Unity Fabric Industries Ltd (Unit-2)

15th & 22nd July 2019

Observations

Bracing layout

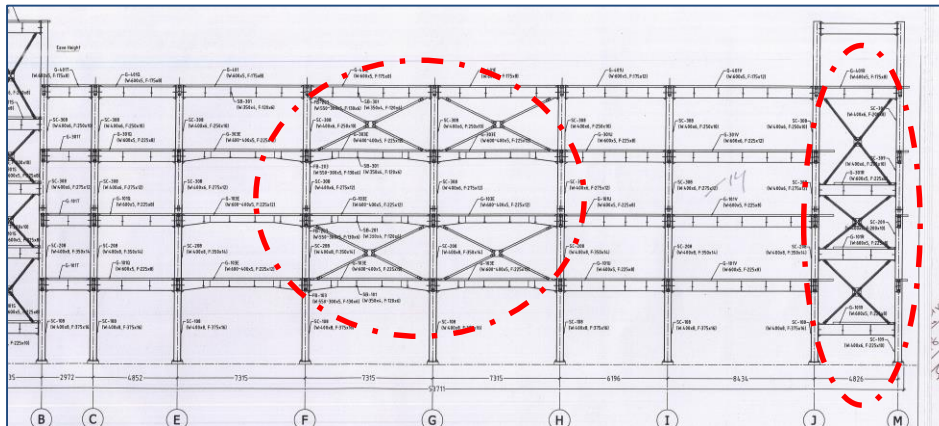
Bracing has not been installed

In the structural drawing, bracing was suggested but not installed on site. The factory engineer is required to check the bracing requirement of the structure and install the necessary bracings accordingly.

Bracing not installed on site

Sectional details of grid 2

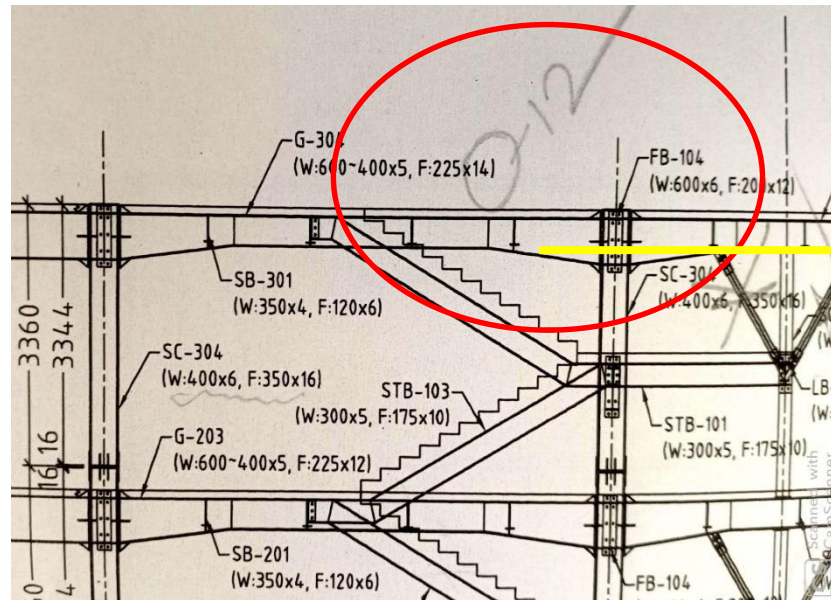
Inconsistency between as-built drawing and as-built condition

Flange thickness of steel beam on grid-02 was found 12 mm instead of 14mm. On the other hand, 3rd floor roof was under construction so that the rafter size of the roof could not be verified.

12 mm thick flange instead of 14 mm

Garbage Shed

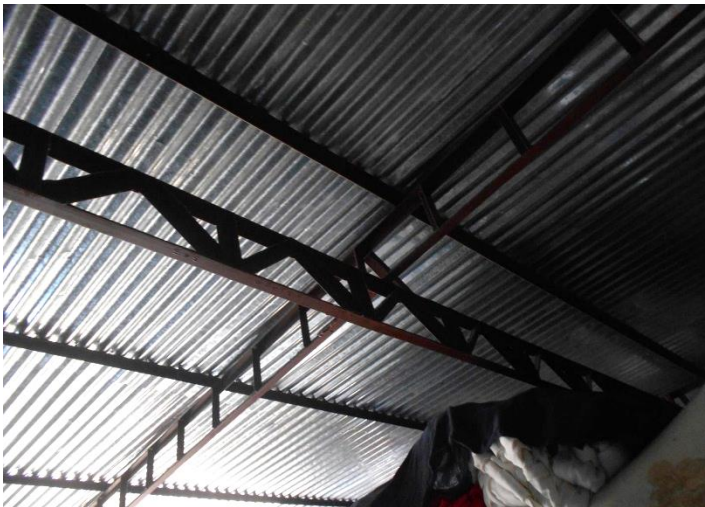
Lack of as-built documents

No documents were available for Garbage Shed. Building engineer is required to prepare “as constructed” drawings with complete structural information.
